ADDENDUM No. 1

ITB No. 4664

Fiber and Conduit Construction for the DDA District Technology Park

ANN ARBOR FIBER RING ONE LINE

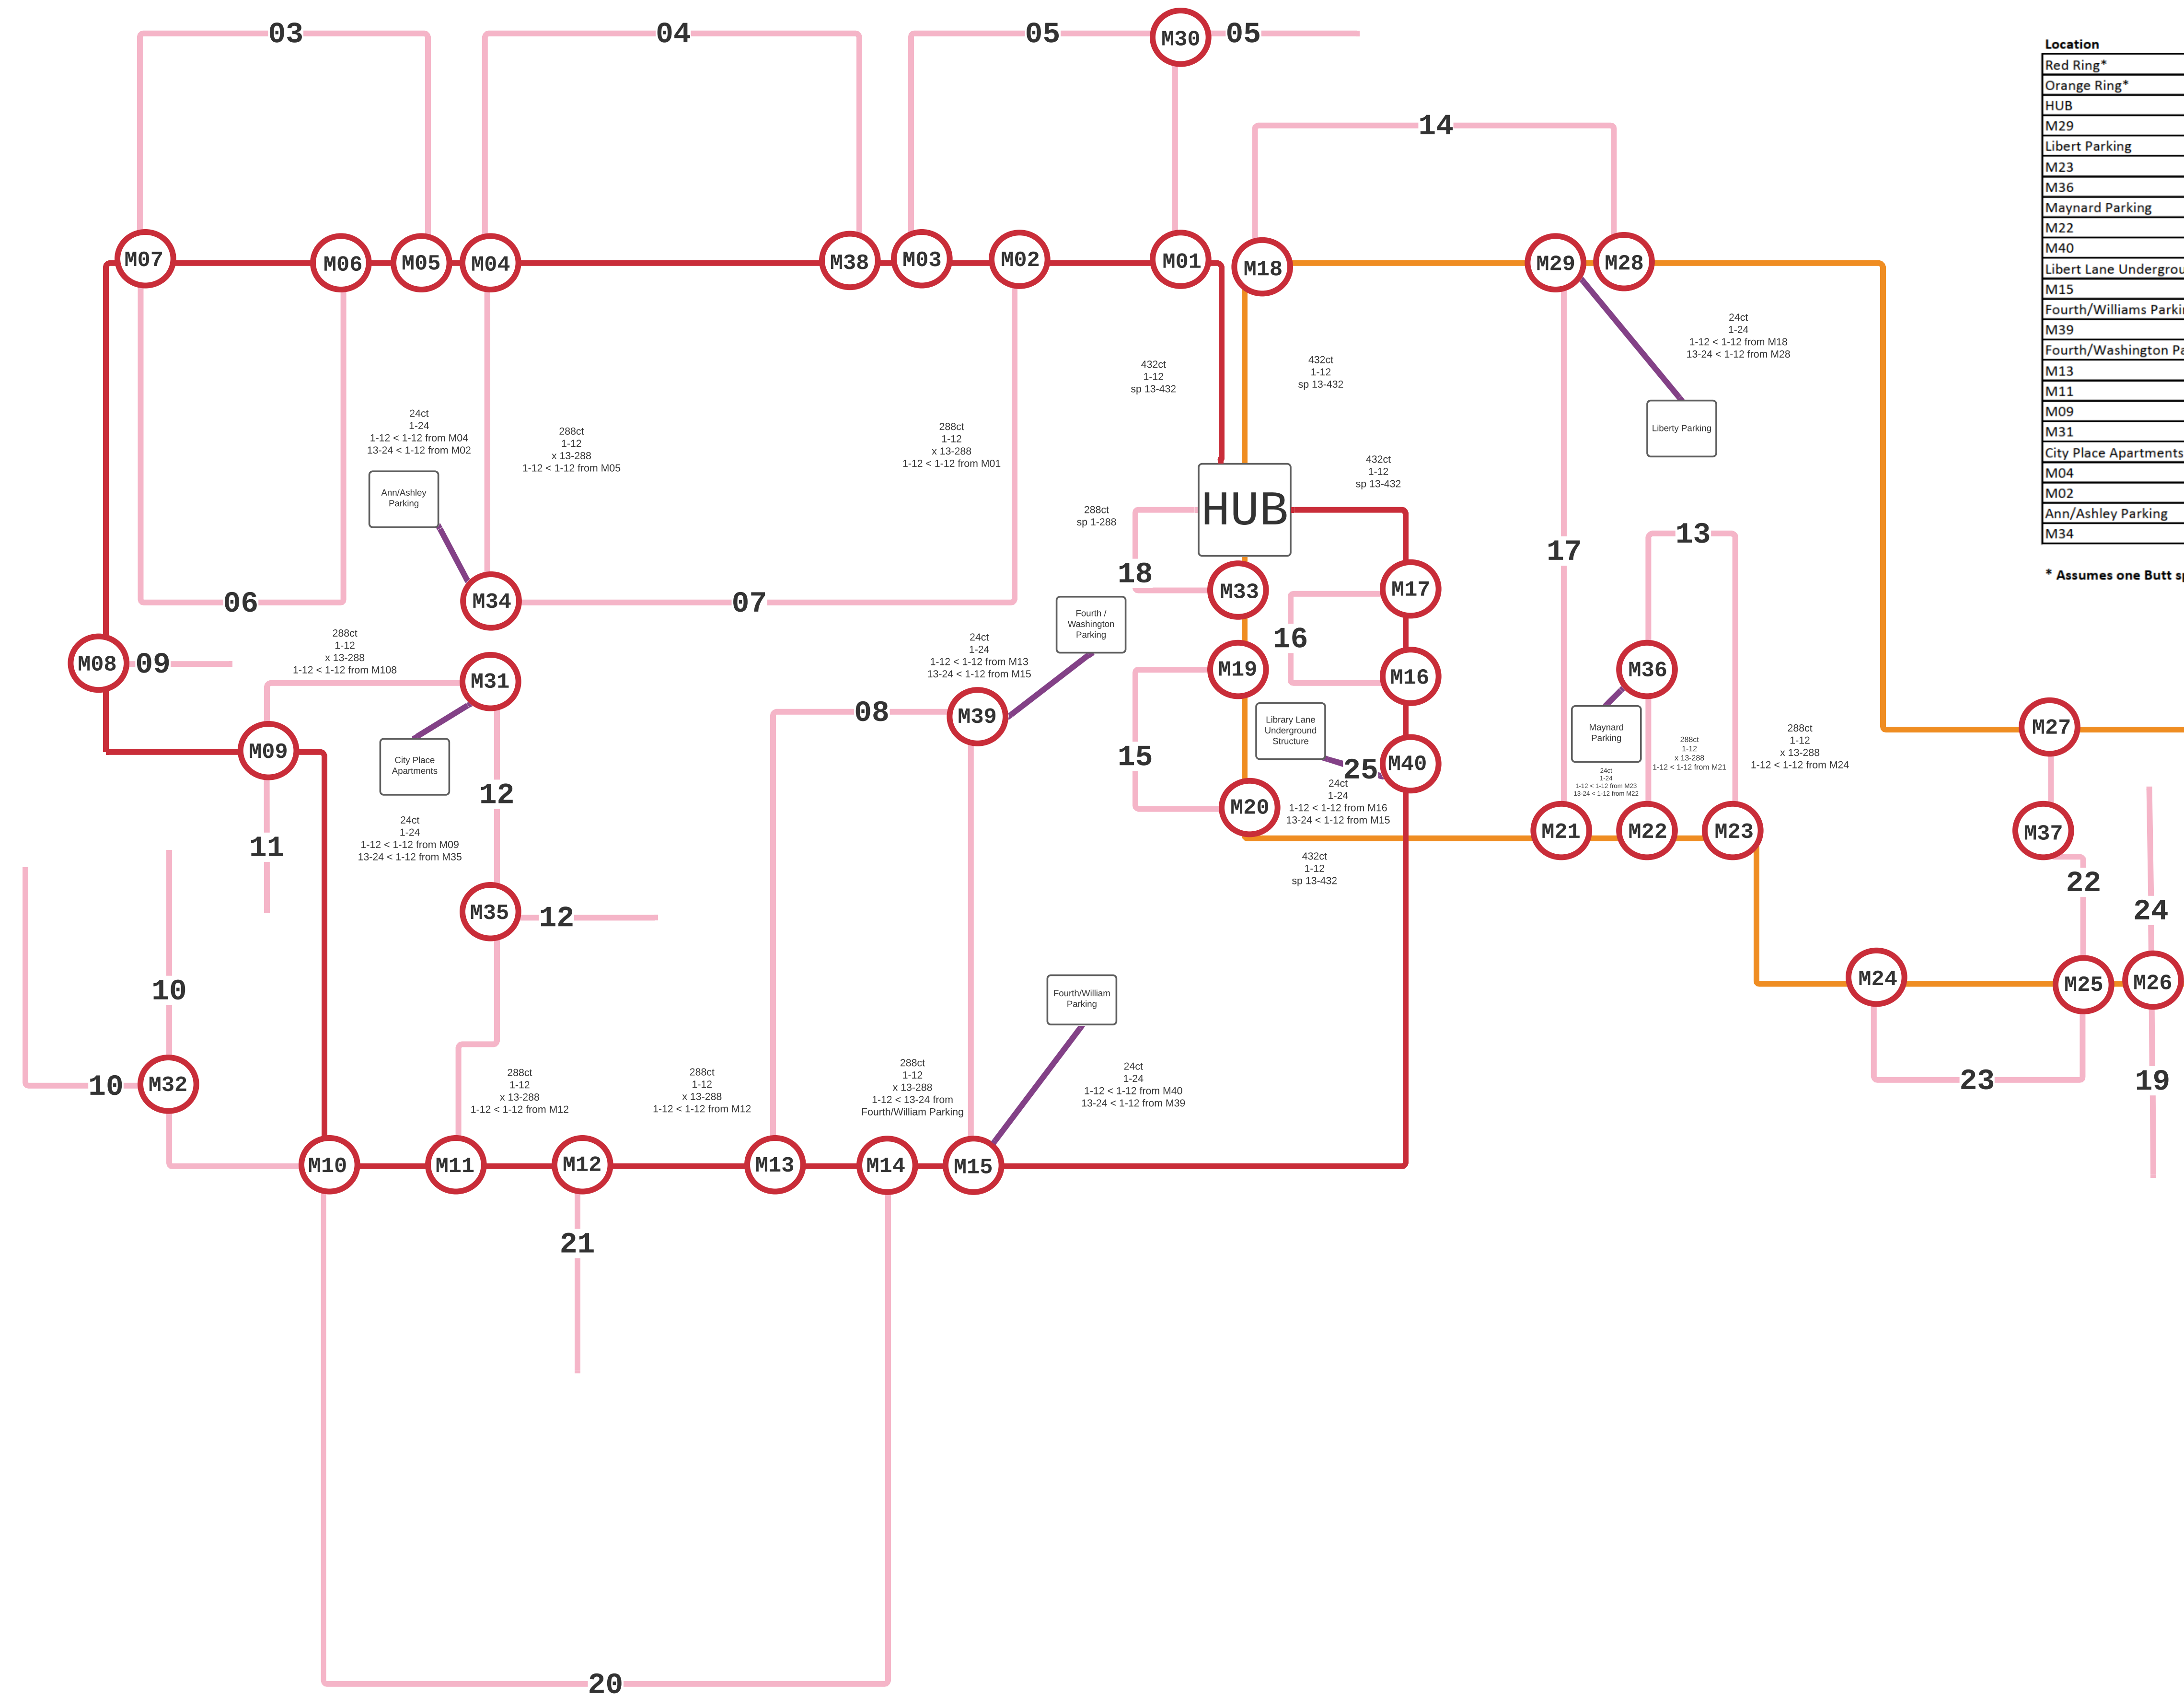
Question 1: Would you please provide a fiber optic splicing plan showing the splicing details?

Answer 1: Please see the attached fiber splicing plan and a description below:

- a. Hub (Justice Center)
 - i. 4-backbone cables (1728 splices) plus an additional 288 splices will be required for termination into patch panels in the City of Ann Arbor Data Center (Justice Center). Total splices – 2,016.
- b. Reel end butt splices:
 - i. Estimated 22 will be required. Total butt splices required is 864.
- c. Parking Garages:
 - i. Involves splicing of 14 slice cases of 24 splices each for a total of 336 splices.
 - ii. 3 pair in and 3 pair out to each parking garage. Total splices 84.
 - iii. Splices for the parking garages– 420
- d. Total splices for entire project - 3300
